ILT local_pattern specification

(in support of comments 415, 416, 417)

Adee Ran, Cisco

Figure 178B-8—Training control state diagram

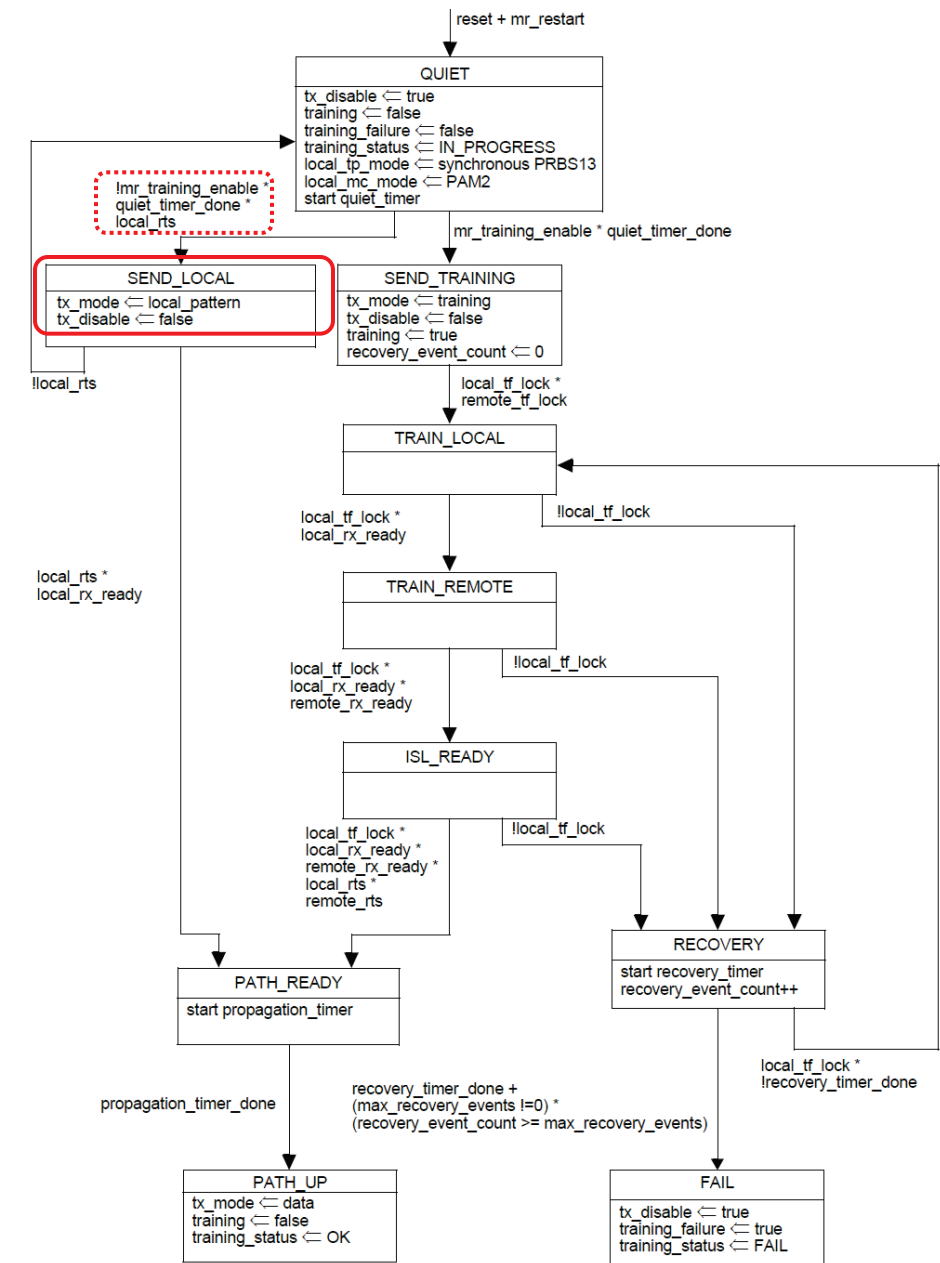
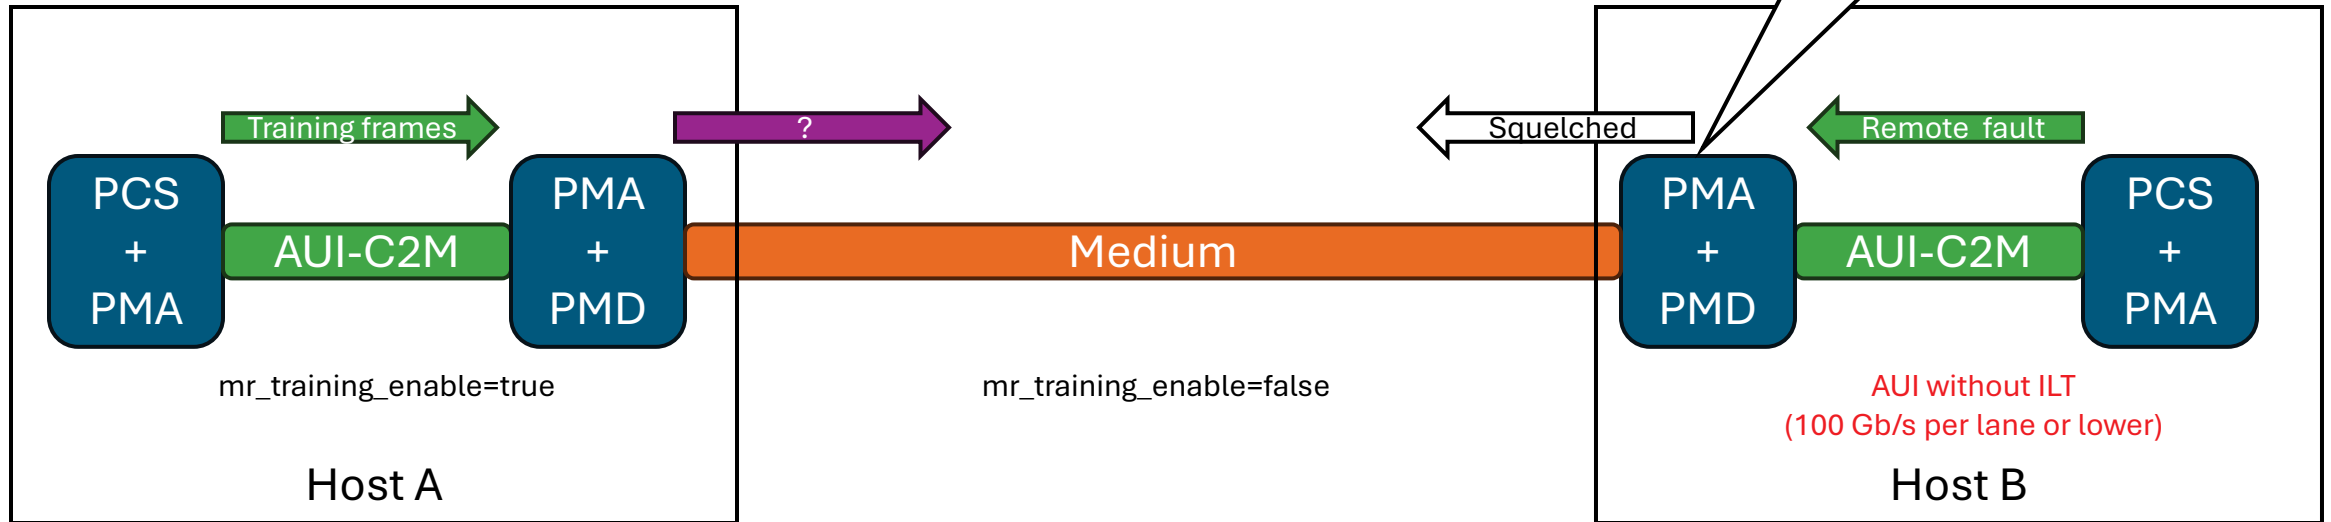
- The left-hand part of the diagram is used when `mr_training_enable=false`.
- While `local_rts=false`, state is QUIET
 - Auto-squelch
- When `local_rts` becomes true, it is signaled to the peer by enabling the transmitter
 - But what signal should be transmitted?
